FOR NEXT TAB TECH

INTERNAL USE ONLY

Main issues on leaving site:

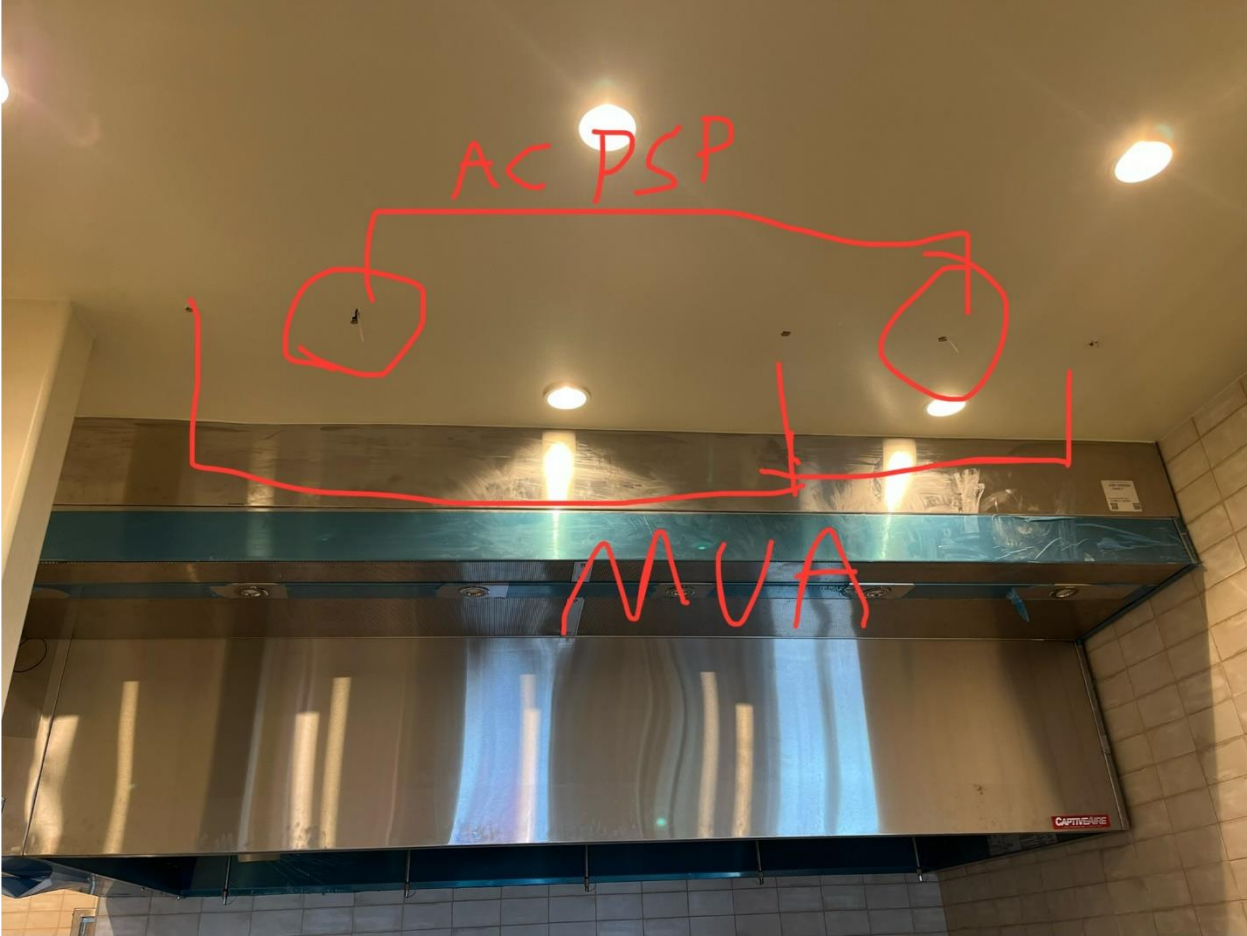
Attached picture are for the damper cable locations and what they go to
